TECHNICAL EVALUATION REPORT

AUDIT FOR MARK I CONTAINMENT LONG-TERM PROGRAM - STRUCTURAL ANALYSIS FOR OPERATING REACTORS

NORTHERN STATES POWER COMPANY
MONTICELLO NUCLEAR GENERATING PLANT

TER-C5506-326

Figure 1. Strain Gauge Locations on RCIC Turbine Exhaust Line

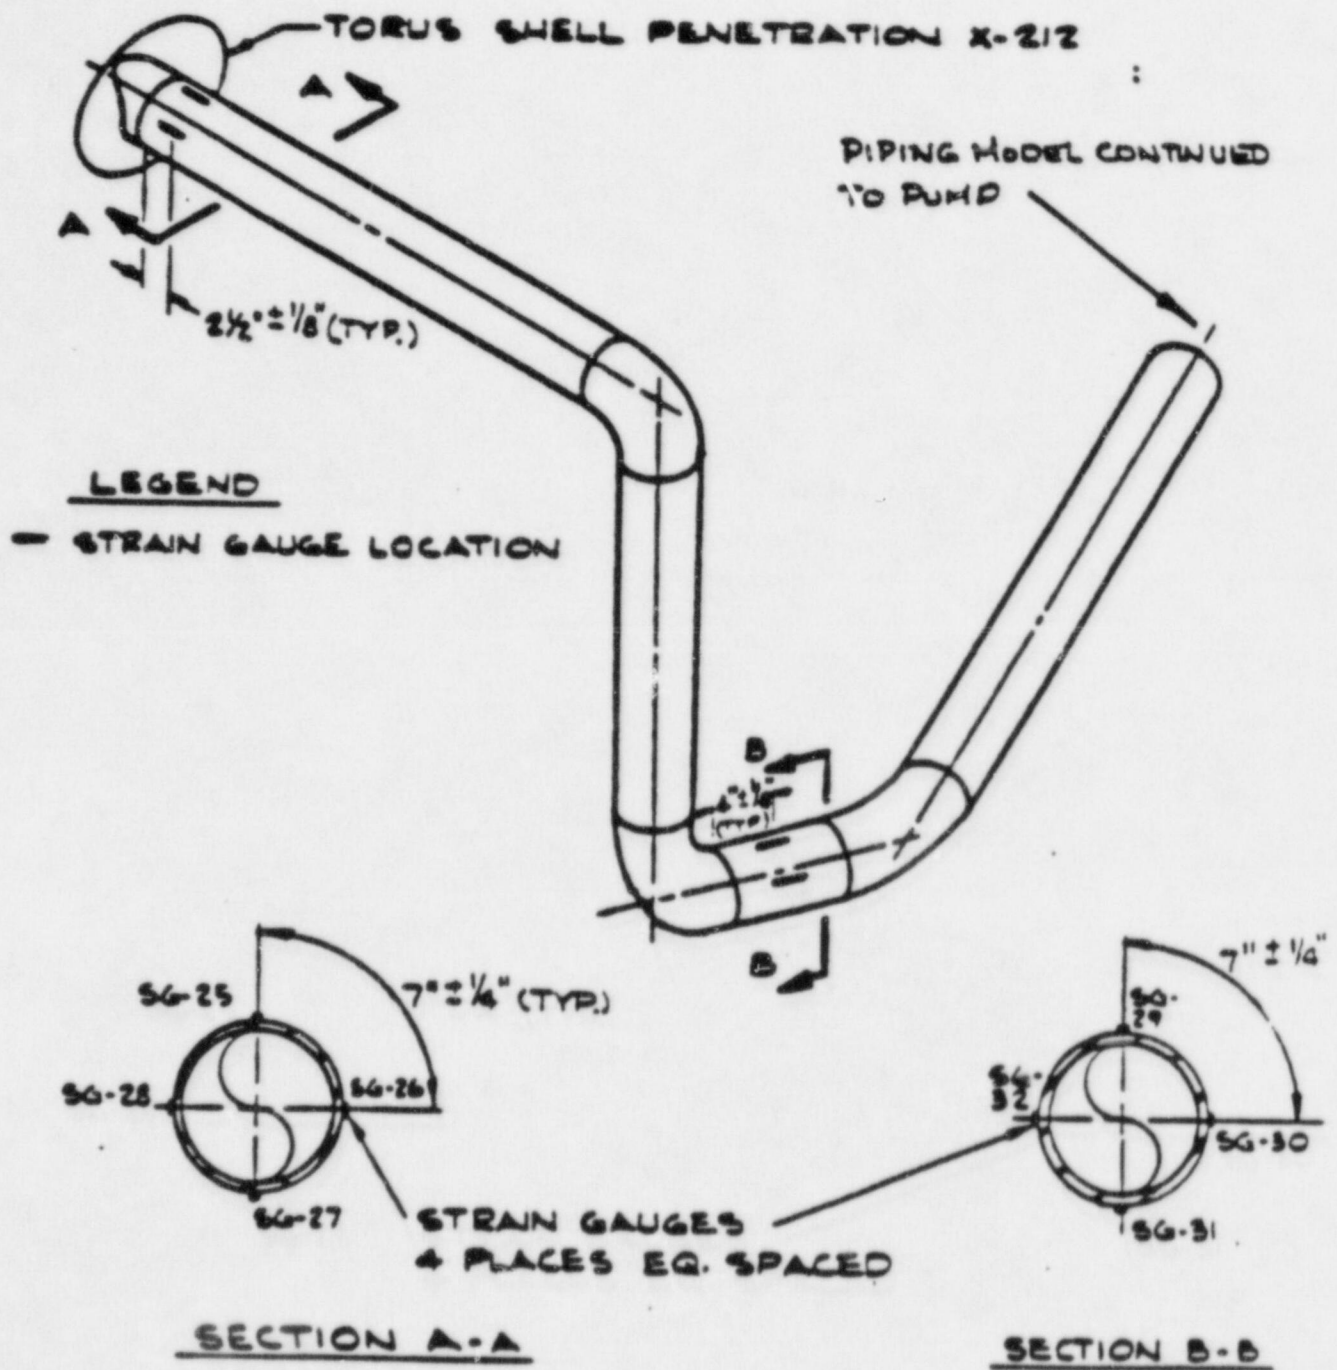
RCIC turbine exhaust line (RS3-8 in-HE) approximately 1 foot and 20 feet from the torus penetration, as shown in Figure 1, were used for comparison. The tests were conducted by actuating one safety relief valve under cold pipe and normal water leg conditions with a reactor power level of 80%. Plots of strain time histories were recorded during each test and were compared directly with the predicted values obtained by the CMODF program.

The Monticello SRV test strain gauge data (converted to stress) were compared with the predicted stresses obtained by the CMODF program. The responses on the time domain and frequency domain (by Fourier transformation) at strain gauge locations were compared with those obtained by the analysis. In addition, the maximum stress values were used in the comparison. The results indicated that a factor of conservatism in excess of 3 was observed in the analysis.

Based on FRC's review of various stress time histories and the maximum stress level of the test data and analysis, it is observed that there is conservatism associated with the analytical procedures. This conservatism could be attributed to the following sources: methodology by which loads were generated, low damping values used in the analysis, possible nonlinearity resulting from pipe supports. The comparison between the test and predicted

values indicated that there is conservatism associated with the analytical procedures, which provides a basis for alleviating the concerns related to some calculated stress values presented in the Licensee's original submittals.
